New Folder Name Interface with Beam
Tube Installation T950002

Contract PP150969
 Control No. 950214-1

Subject: Interface with Beam Tube Installation

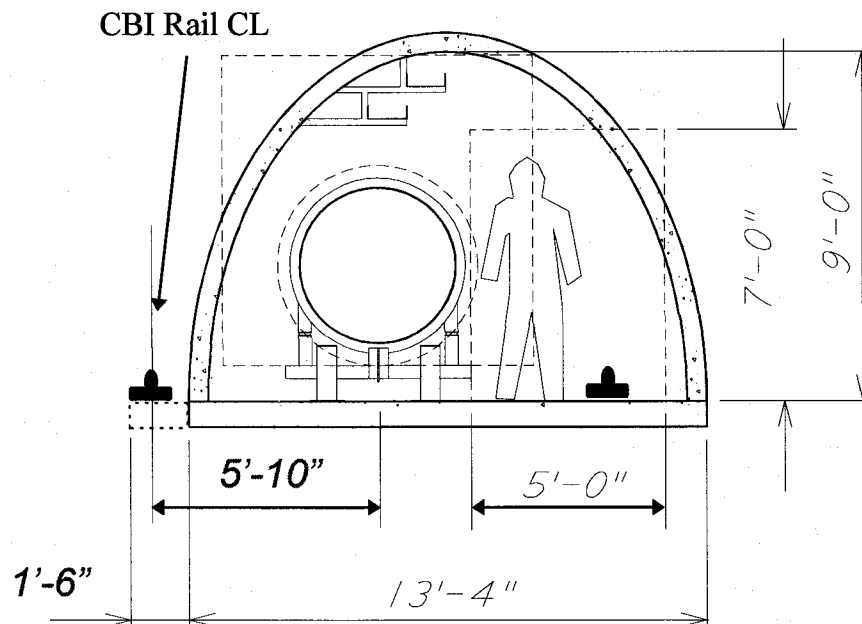
We are about to issue a concept review package of the Beam Tube Enclosure and need to interface with CBI to ensure our approach will also satisfy their needs during installation of the beam tubes. The following sketch shows 13'-4" wide slab foundation for the beam tube foundation. This has been down sized from the 16'-6" that they have probably been designing to. Given the fact that for the two sites, this slab is about 16 kilometers long, you can understand that this change has a significant cost savings impact.

1. We are interested in whether this approach has an impact on their rail mounted clean room, weld station shelter, or leak test shelter. Base on the sketches that we have seen of their approach, the center to center track gauge is 11'-8", and the beam tube is centered between the rails. Based on our current approach, and assuming that they intend to place their rails on our slab, we will need to extend the left side of our slab approximately 1.5 feet to accommodate the left side rail.

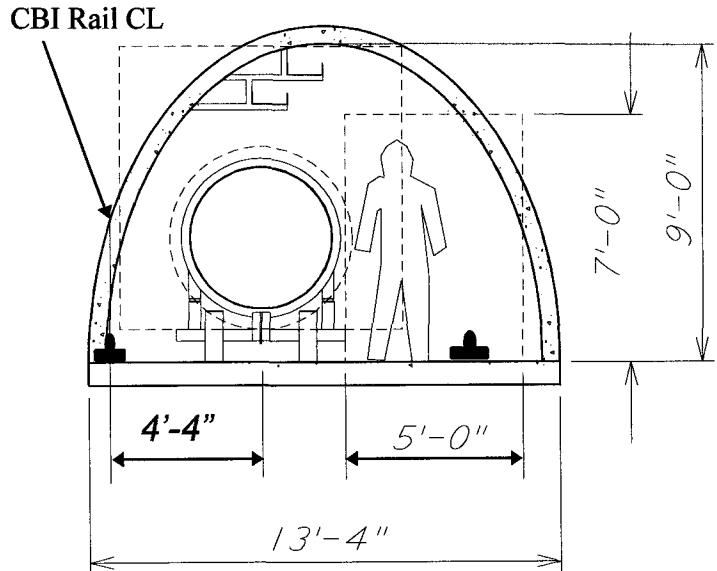
2. Another alternative is to move their rail so it will sit on the slab as shown. This appears to be a workable alternative since it will not affect the arrangement of their 8'-0" wide clean room trailer, but it may impact the weld station and test station shelters. Currently the distance from the centerline of the beam tube to the left edge of the slab is 4'-10". If their rail is moved 6" inboard of that, it would then be 4'-4" from the centerline of the beam tube (the right side rail can remain at 5'-10"). Will this work?

3. We are also interested in their alignment/leveling method. If they are attaching a laser scale site, then we need to know where it is attached, and what it looks like.
4. Lastly, does the cross section shown allow sufficient working space for adjustment of the support leveling features that they have designed?
